OBERHEIM ELECTRONICS, INC.
ENGINEERING CHANGE ORDER

402

OB-8

SCHEMATIC 1679A SHEET 2

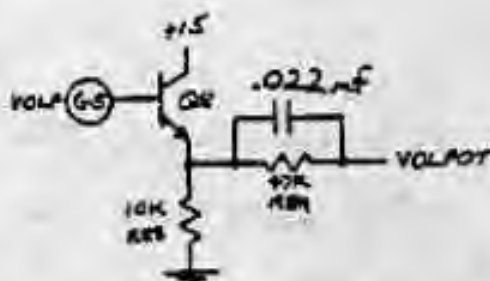
ADD .022uF CAPACITOR IN
PARALLEL WITH R89.

TO ELIMINATE NOISE WHEN CONTROLLING THE VOLUME WITH
AN EXTERNAL LOW IMPEDANCE VOLTAGE SOURCE.

OB-8 POT. Board 1&2 1681A C

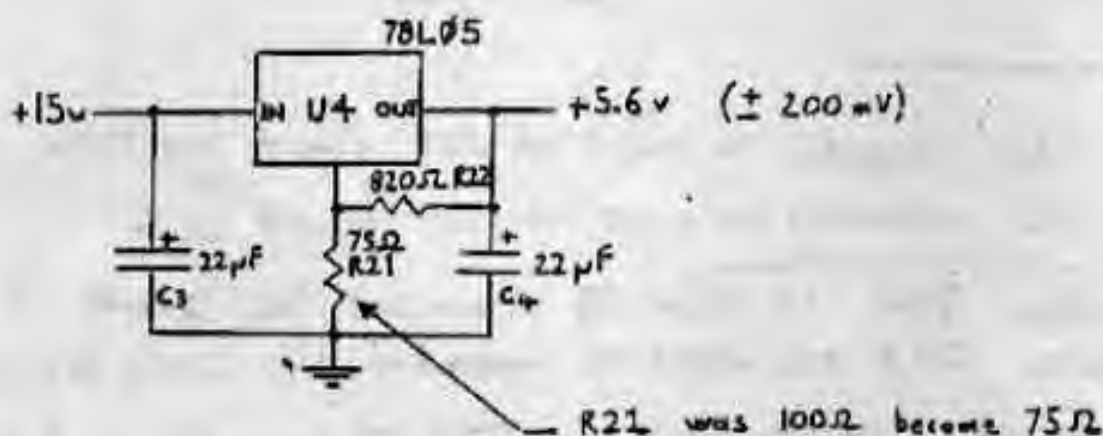
Reduce output of 5.6v Supply.

Increase the active range of the front panel pots

SCHEMATIC 1679 A, SHEET 2
OB-8 PROCESSOR BOARD

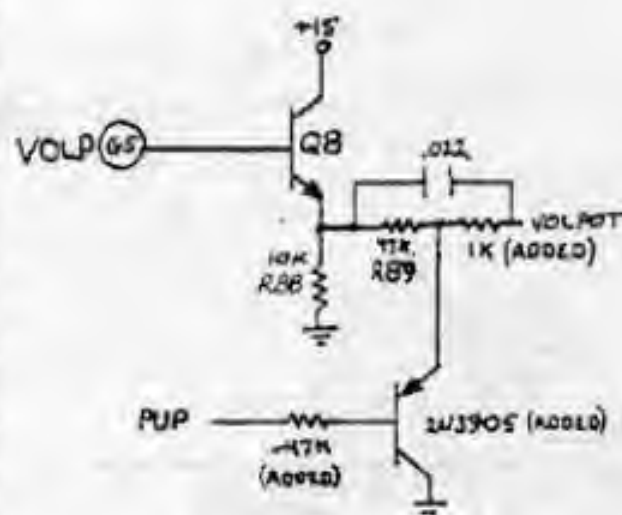
ADD PNP TRANSISTOR, 47K AND 1K RESISTORS

TO REDUCE POWER-DOWN GLITCH AT OUTPUTS

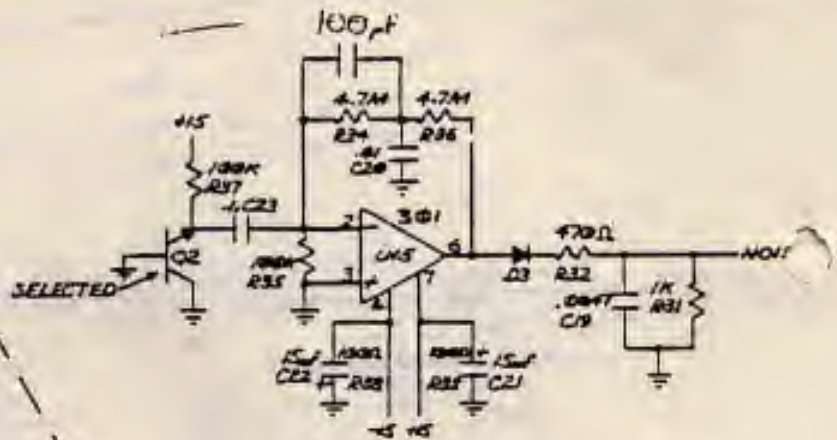
ADD A 100pF CAPACITOR
IN PARALLEL WITH R34

ON REVISION A PROCESSOR BOARDS, WHEN A SEQUENCER IS CONNECTED,
DISTORTION BECOMES PRESENT IN THE NOISE GENERATOR.

OB-8 BEND BOX 1680A SHEET 1 OF 1

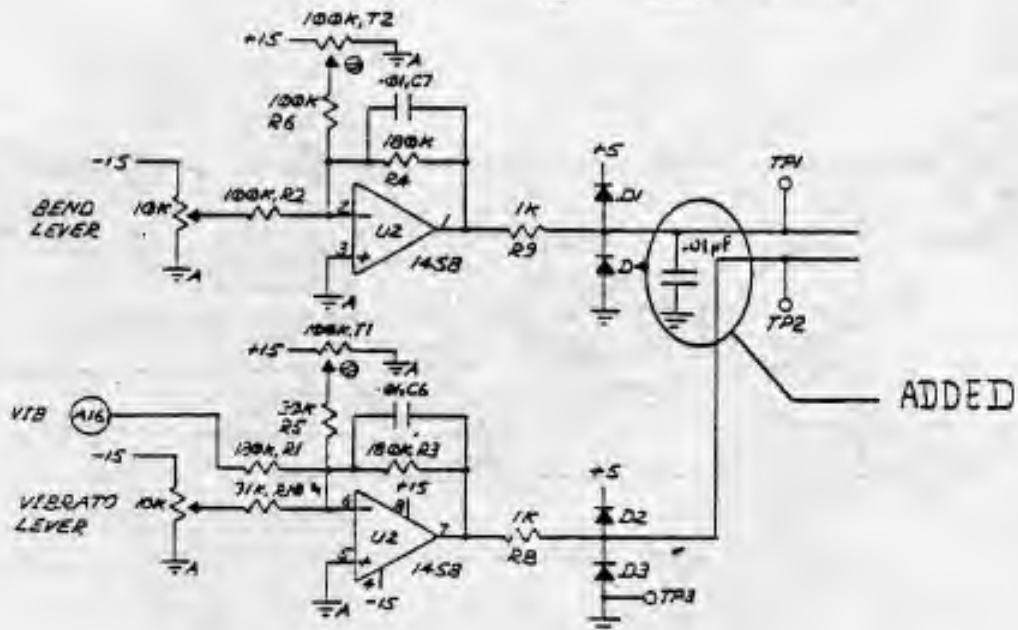
- REMOVES NOISE MODULATION FROM BENDER LEVER

PROCESSOR BOARD- POWER SUPPLY
1679A SHEET 4 of 4

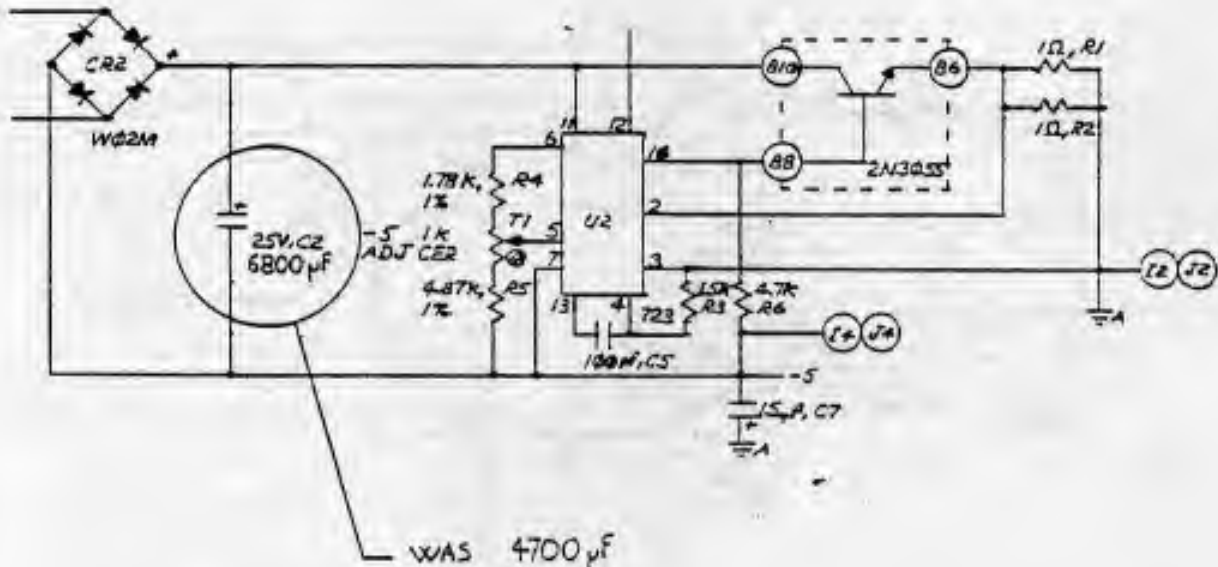
WHEN THE NEW POWER SUPPLY TRANSFORMER (REF. 561021) IS USED, THIS CHANGE DECREASES THE OUTPUT THUMP ON POWER OFF.

VOICE BOARD 1682A SHEET 2 OF 3

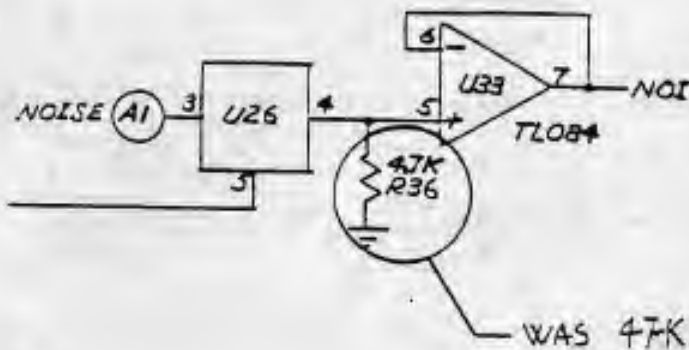
REMOVE LEAK OF NOISE GENERATOR WHEN A VOICE IS GATED

1682A VOICE BOARD

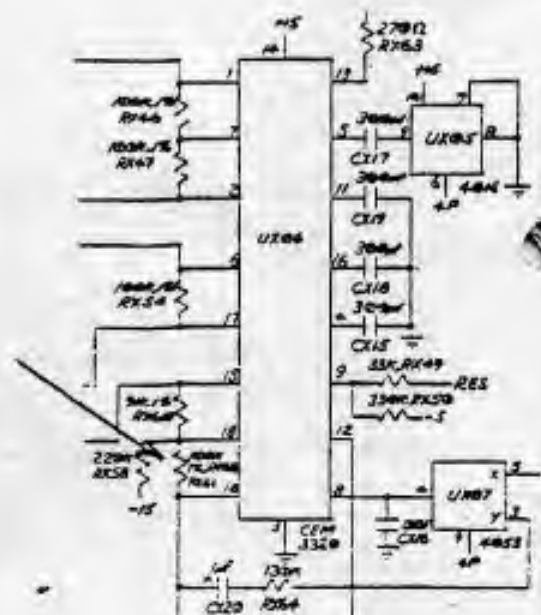
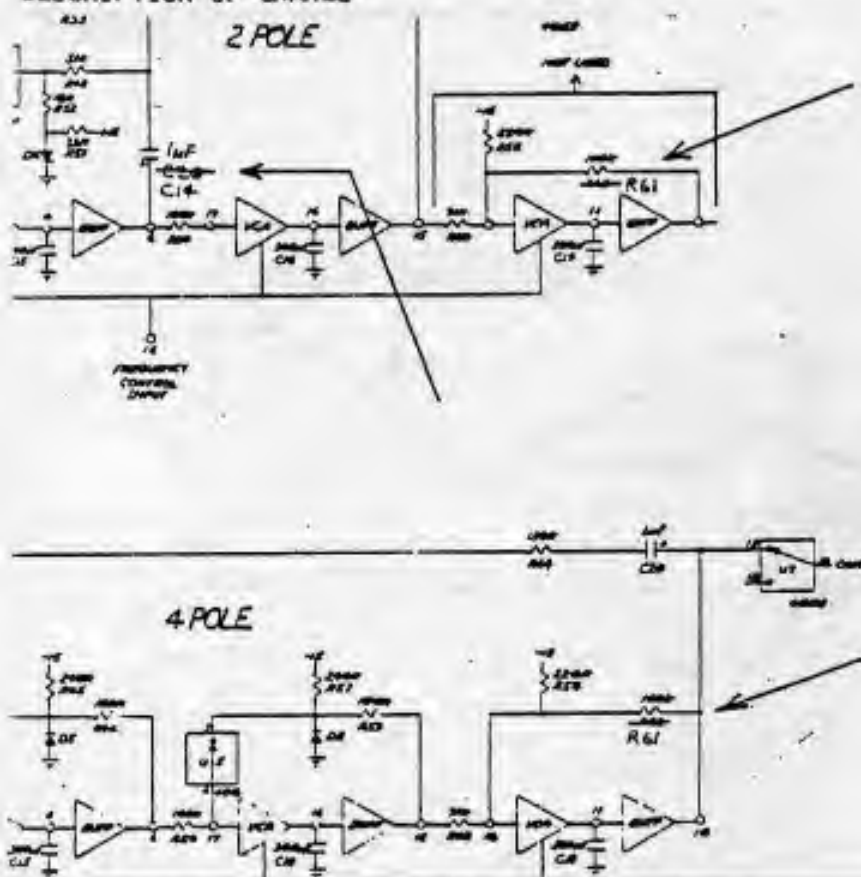
RESISTOR AT UX06 PINS 10, 18 MARKED RX68 SHOULD BE RX61.

CAPACITOR IN 2 POLE/4 POLE CONFIGURATION DRAWING MARKED C20 SHOULD BE C14.

1682 B OB-8 VOICE BOARD (UPPER)

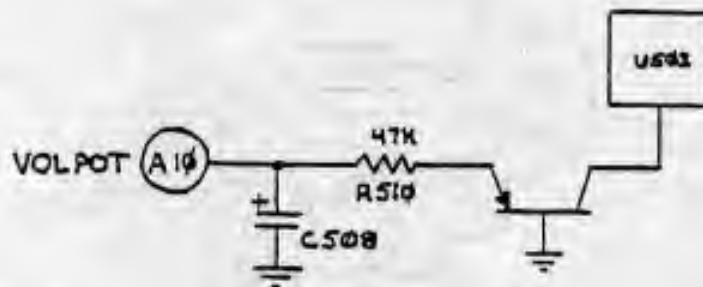
Change C508 from 0.1 μ f Mylar To 2.2 Electrolytic (Upper Voice only)

To eliminate noise at output at low master volume levels

1632 B OB-8 Voice Board
1639 B

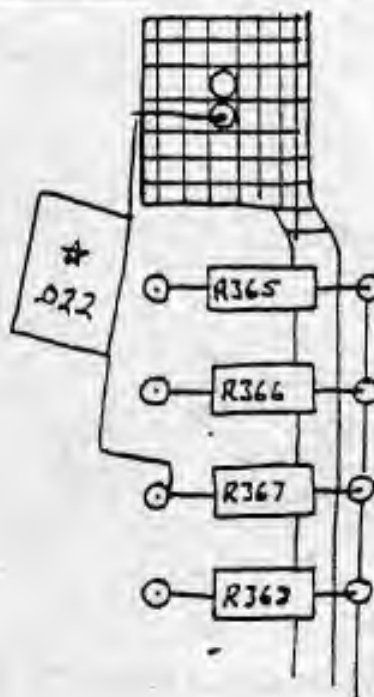
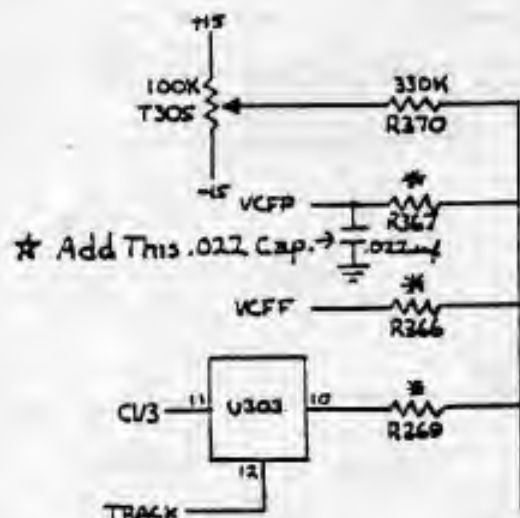
Add a .022 Mylar Capacitor To both The Top and bottom Voice Boards

To Filter-out digital noise picked up along The Filter Pedal line (VCFF) when a Sequencer (05X) is connected.

OB-8 VOICE BOARD 1682 B SHEET 3 of 3

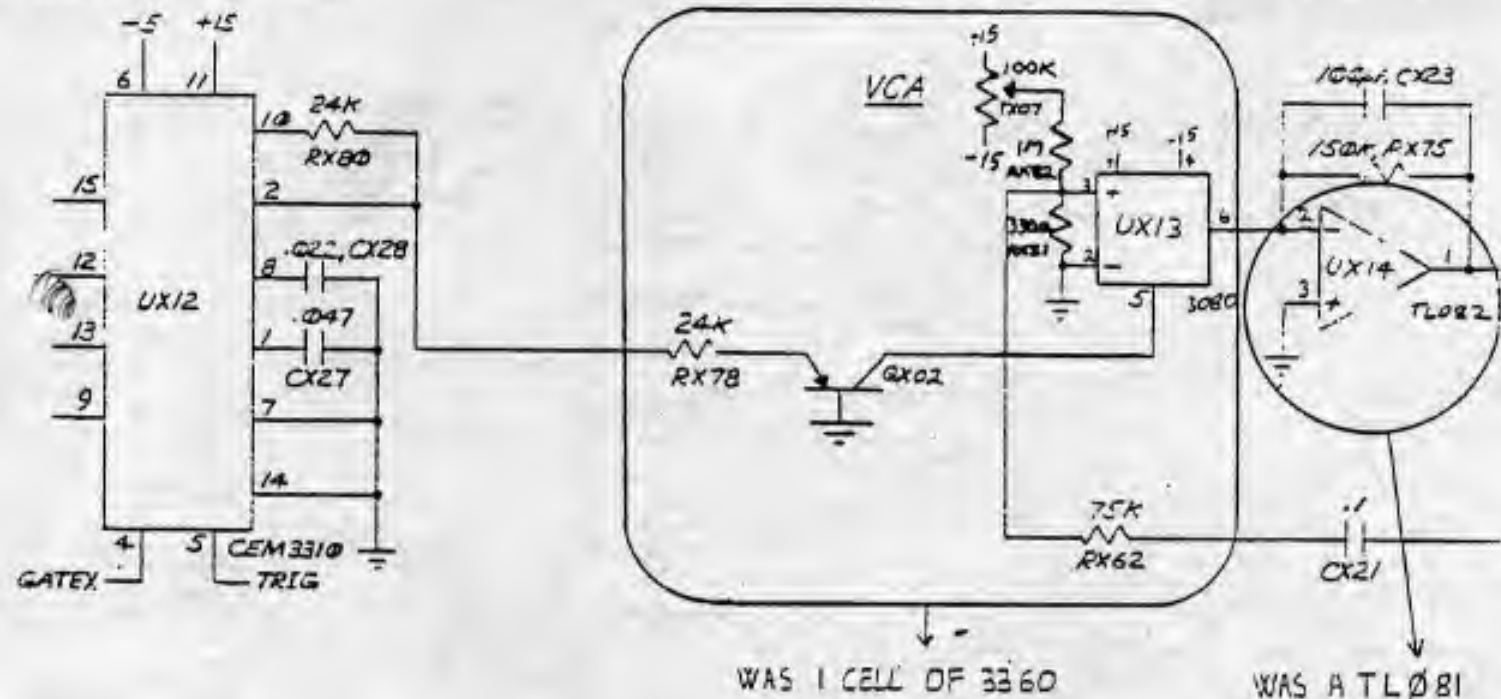
— ALSO: UX08 IS DELETED AND REPLACED BY THE OTHER CELL OF THE TL082 UX14

— RATIONALIZE THE CIRCUITRY

OB-8 VOICE BOARD 1682A SHEET 3 OF 3

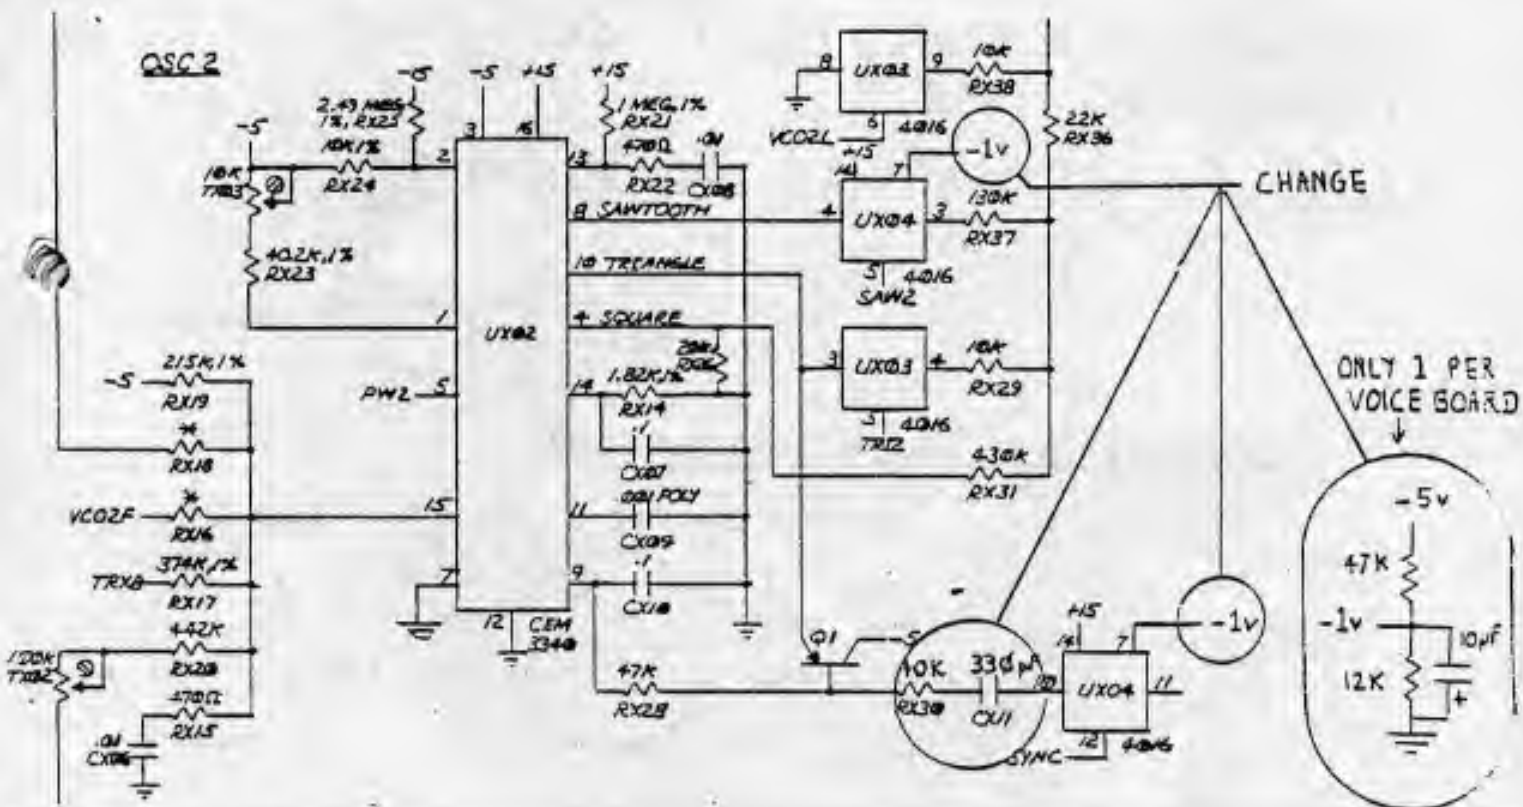
- IMPROVES SYNCHRO SOUND

POT BOARD 1681 B

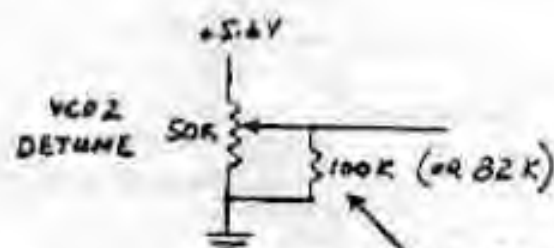
ADD RESISTOR ACROSS POT. TERMINALS.

IF THIS
FAR OFF,
USE 100K

IF THIS
FAR OFF,
USE 82K

TO CENTER OSC 2 DETUNE CONTROL WHEN LED GOES OFF
WITH KNOB SIGNIFICANTLY COUNTERCLOCKWISE OF CENTER.

1679 B - SHEET 1

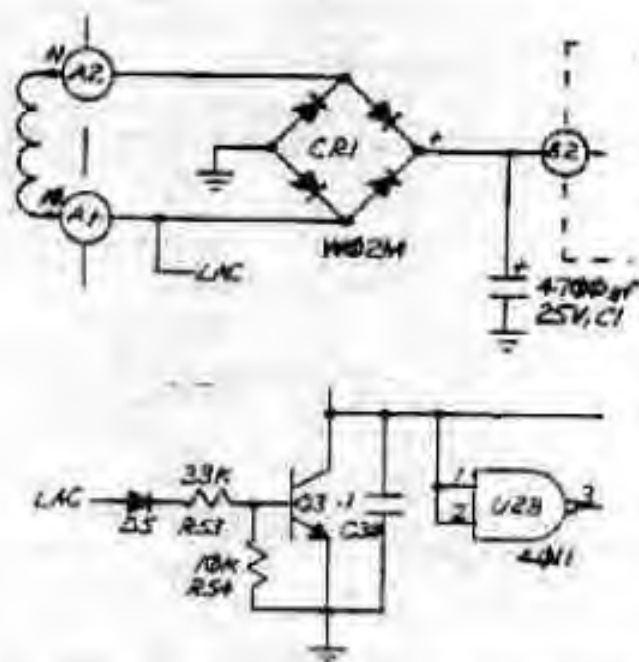
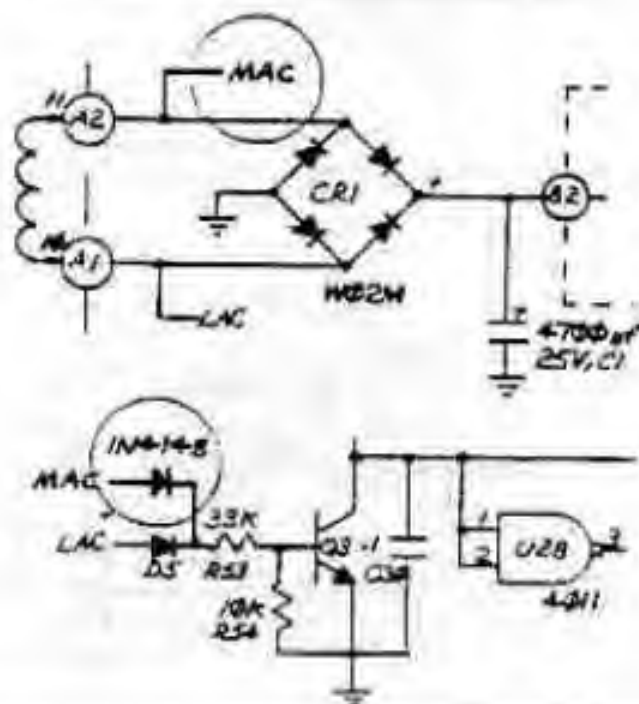
IMPROVE MARGIN OF "PUP" CIRCUIT TO INADVERTENT TURN-OFF, ESPECIALLY AT 50 Hz.

PROCESSOR BOARD 1679B SHEET 1 OF 4

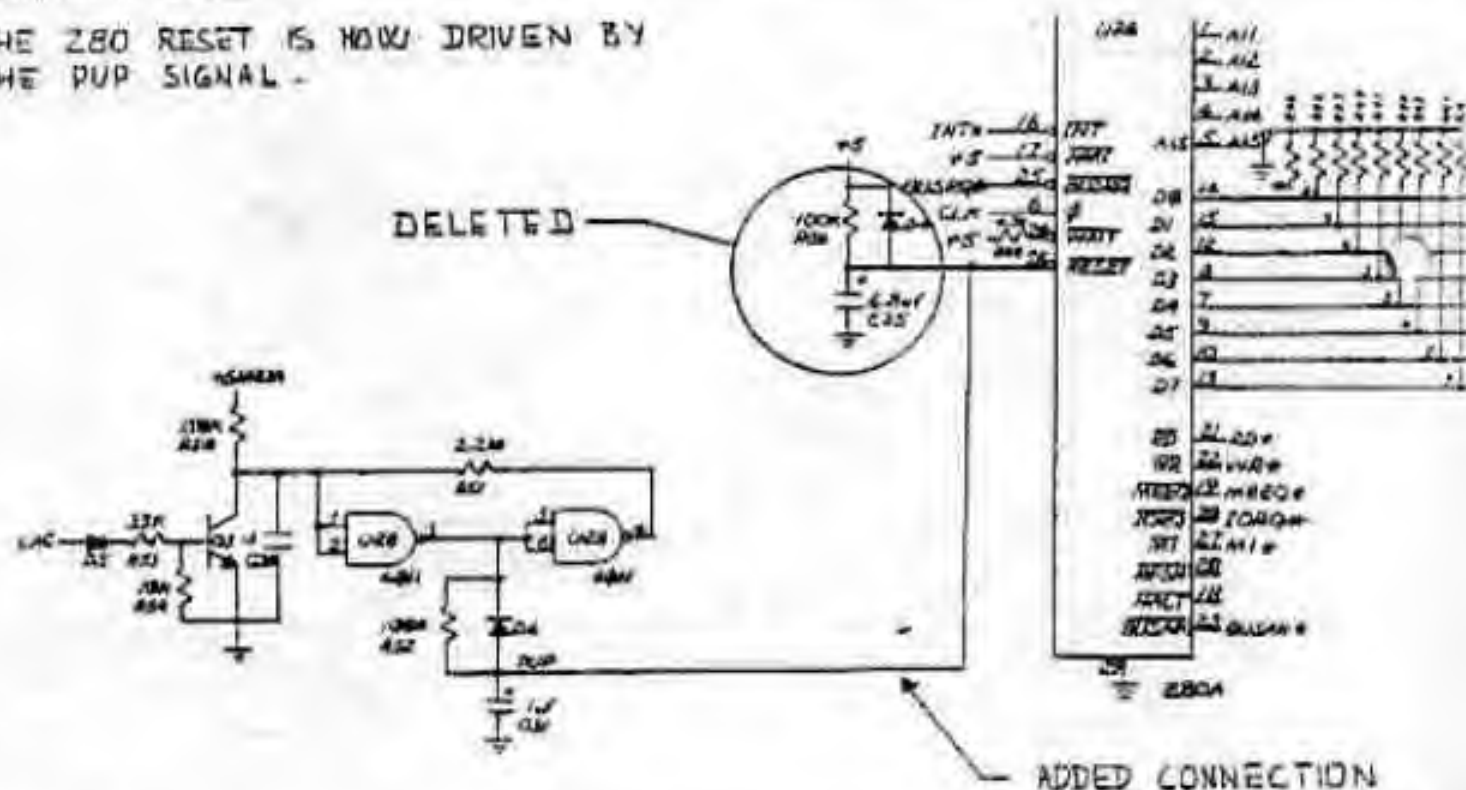
THE Z80 RESET IS NOW DRIVEN BY
THE PUP SIGNAL.

TO AVOID POSSIBLE MEMORY DROP CAUSED BY SHORT POWER DROP

DRAWINGS AFFECTED
POWER SUPPLY

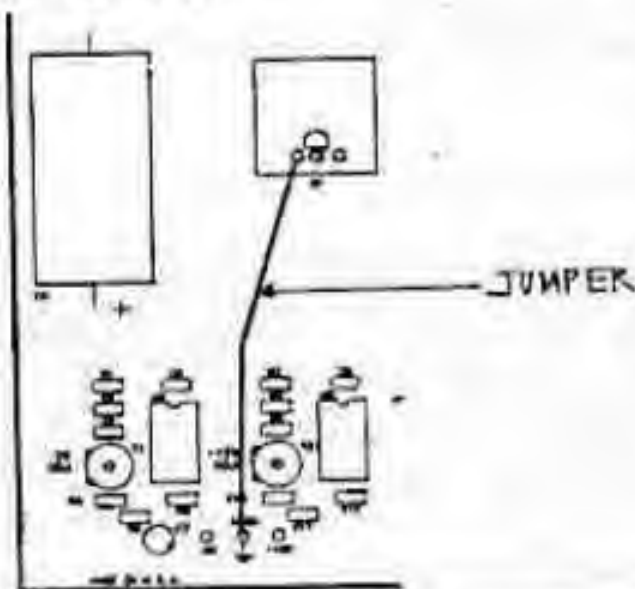
ADD A JUMPER BETWEEN PIN 1 OF THE -15 REGULATOR
7915 (GND) AND THE GROUND REFERENCE TEST POINT.
THE JUMPER MUST BE MADE OF A 18 AWG WIRE (.04 inch / 1 mm)
MINIMUM AND MUST BE SHORT.

TO REMOVE AC HUM ON AUDIO OUTPUT.

OB-8 PRECESSOR BOARD 1679B sheet 1 of 4

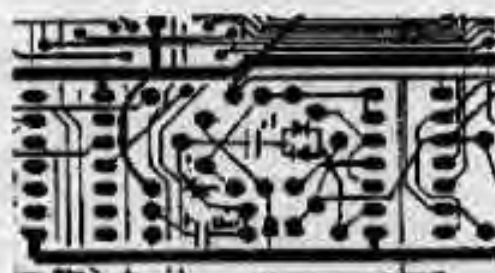
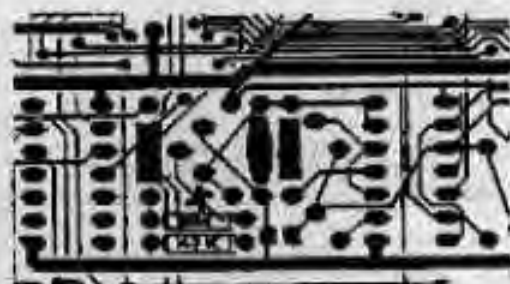
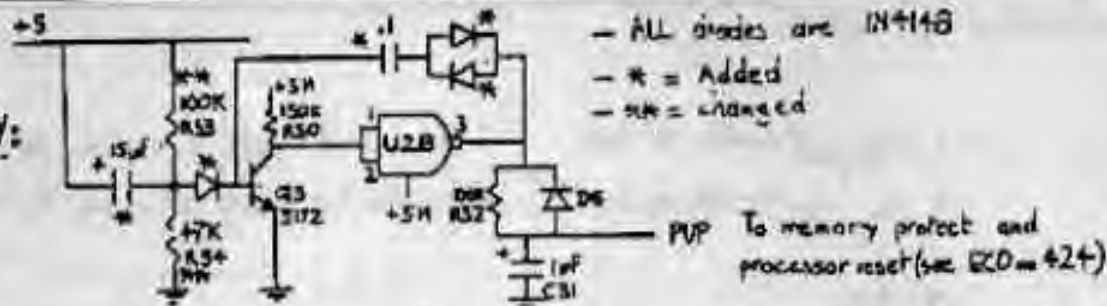
- Remove DS, C30, R31 (Darkened components)
- Cut between Q3 base and R33
- Remove diode added by ECO #23 (under the board)
- Replace RES with a 100K and R54 with a 47K

- Add a jumper between +5 and R53
- Aid from under the board: 2 caps and 3 diodes

- Replace C1 (4700 μ F cap. on 5v power supply) with a 10,000 μ F 16v

- Avoid memory drop.

ECO NO. 419

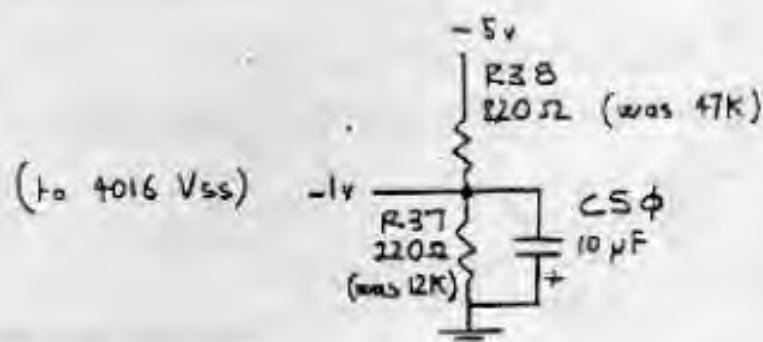
- change value of -1 divider on each voice board

- ALLOWS USE OF SIGNETICS' 4016 &
IDENTIFIES COMPONENTS
